CITY OF NAPOLEON - BUILDING DEPARTMENT
255 West Riverview Avenue, Napoleon, Ohio 43545 - 419-592-4010

RESIDENTIAL PLAN CORRECTION SHEET

ADDENDUM TO Permit No. 01591-(1)
Owner LARRY HUBER
Contractor SELF
Location 1116 GLENWOOD

TO: Board of Zoning Appeals
FROM: Roger O. Freytag, Zoning Administrator ROF
SUBJECT: Request for Variance - Larry Huber -
Required Parking.
DATE: July 14, 1988 B2A88-10

LARRY D. HUBER
 1114 GLENWOOD AVE
 BOCKELMAN'S 3RD
 ADDITION, LOT 20
 6/15/88

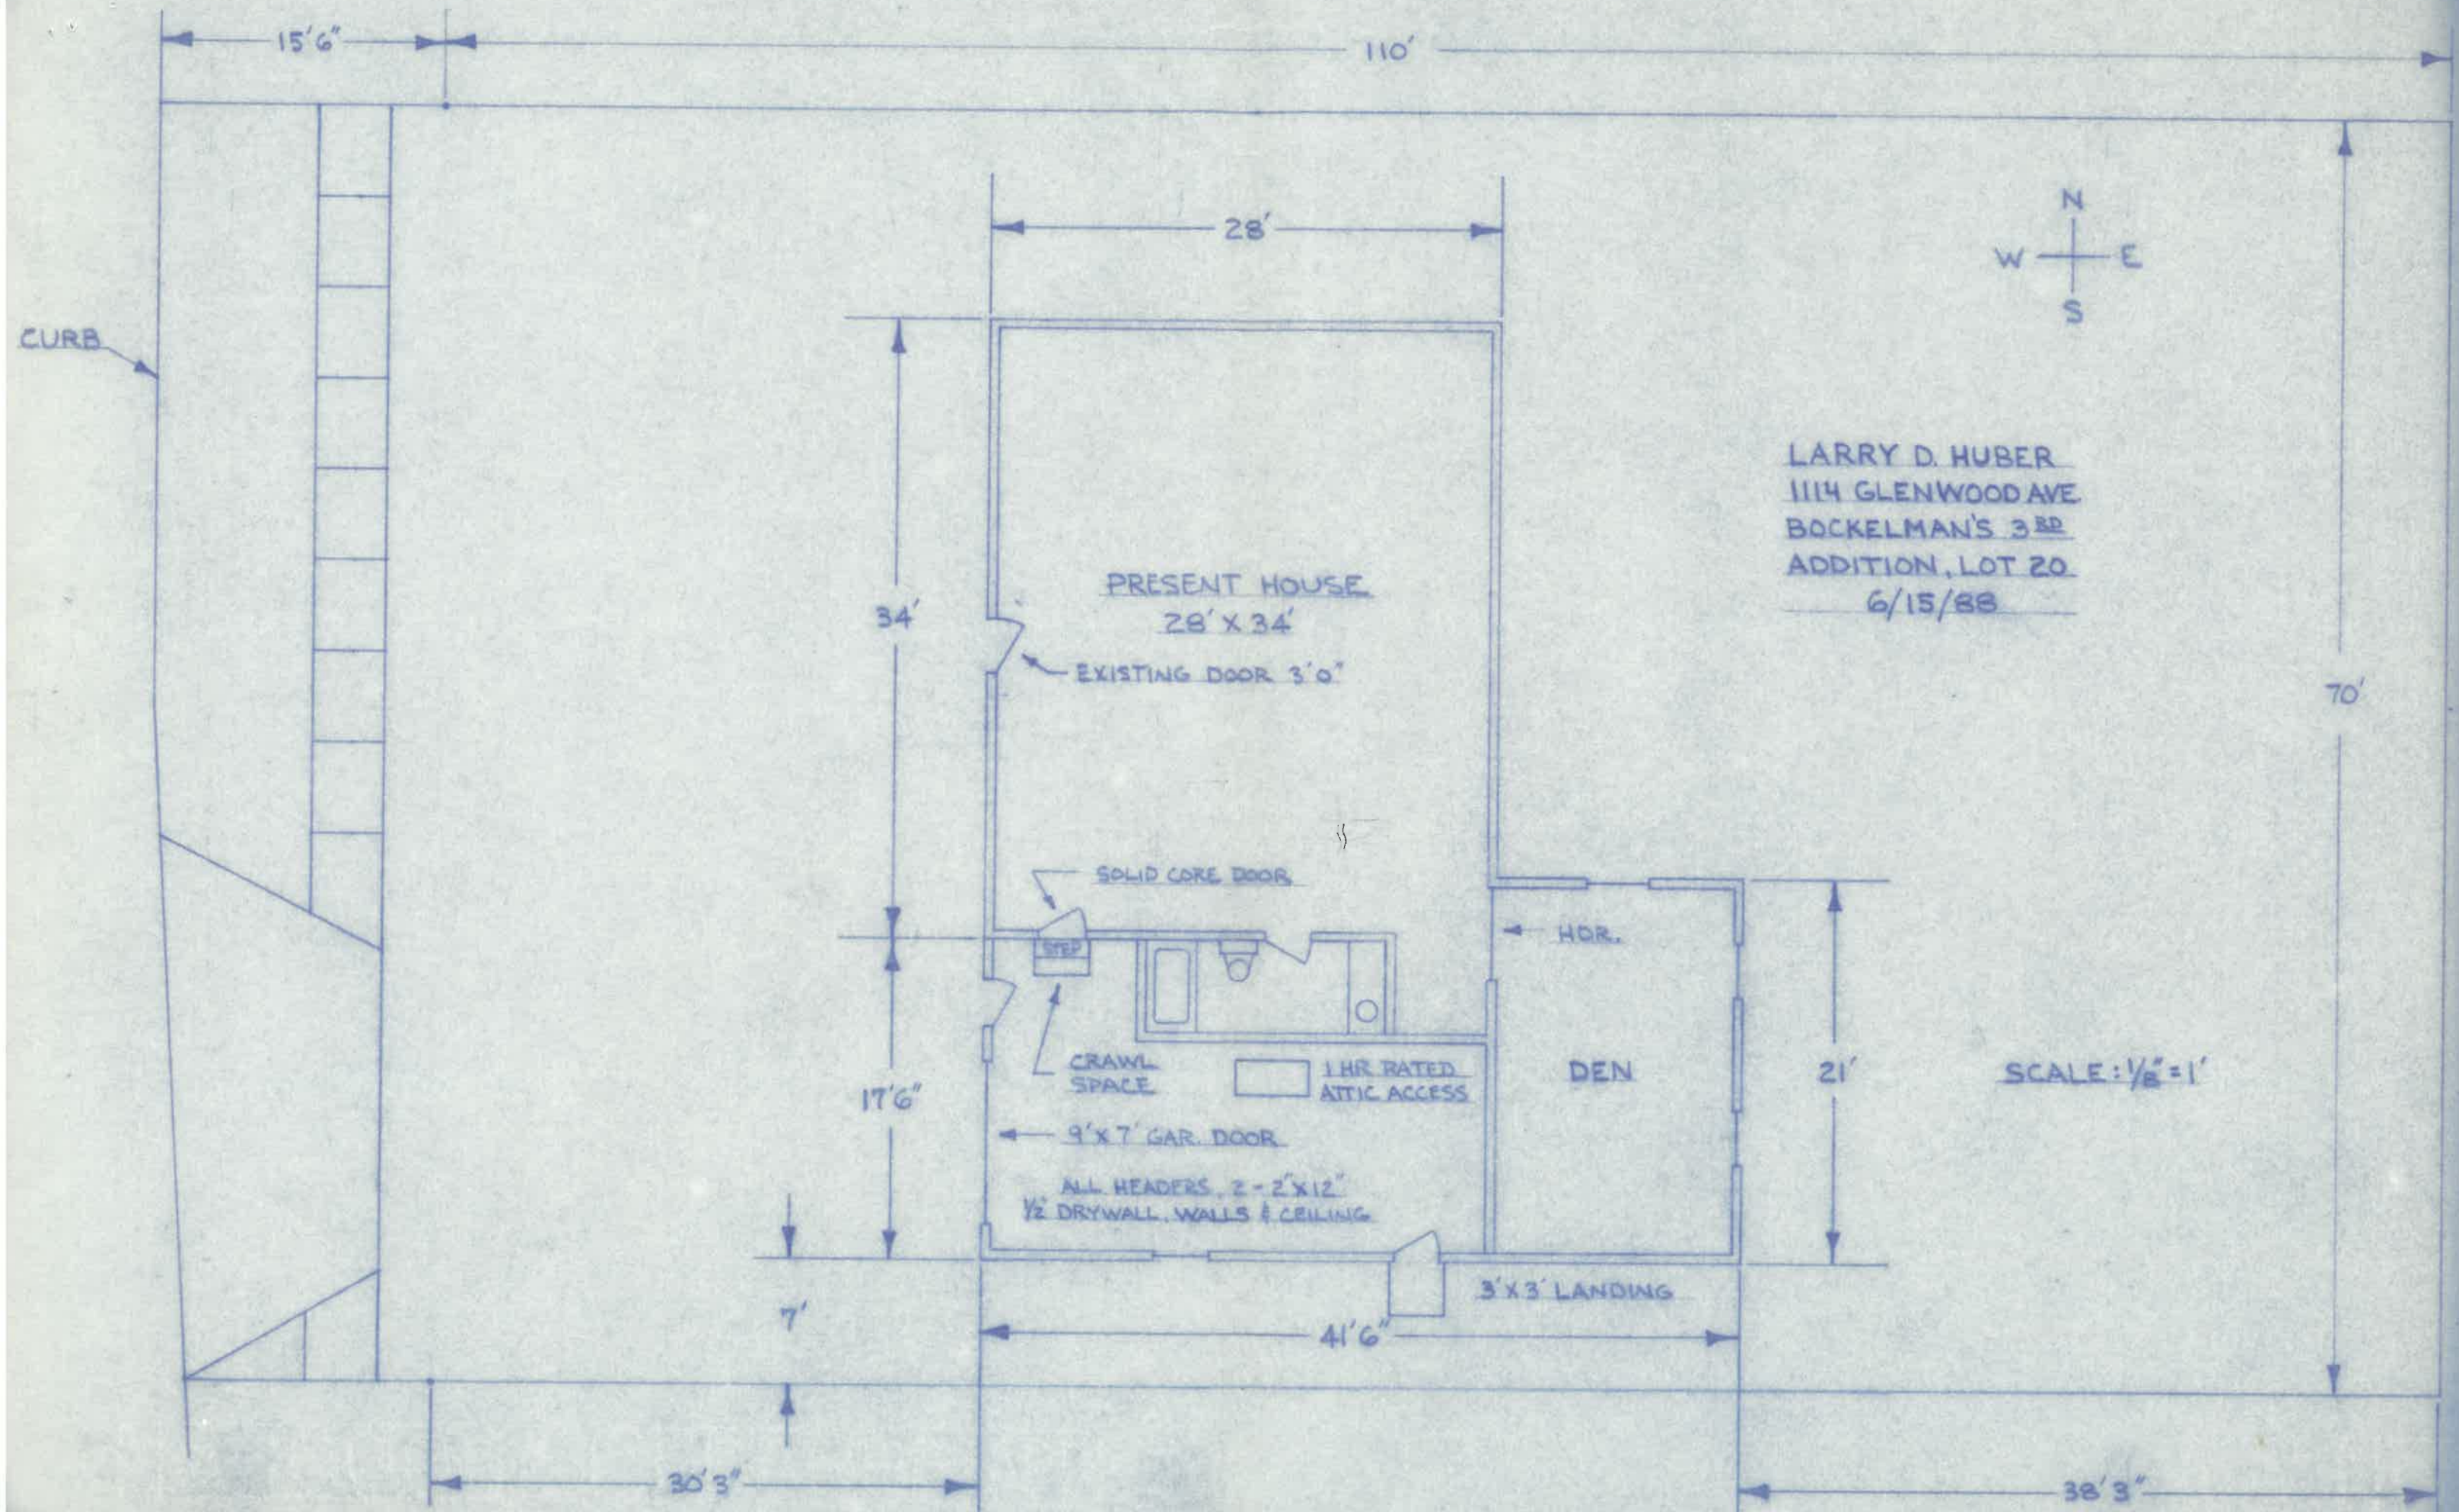
Additional Corrections. INCREASE THE SIZE OF THE GARAGE CEILING JOISTS TO 2x8 @ 16" O.C. WITH TIES FROM CEILING JOISTS TO RIDGE
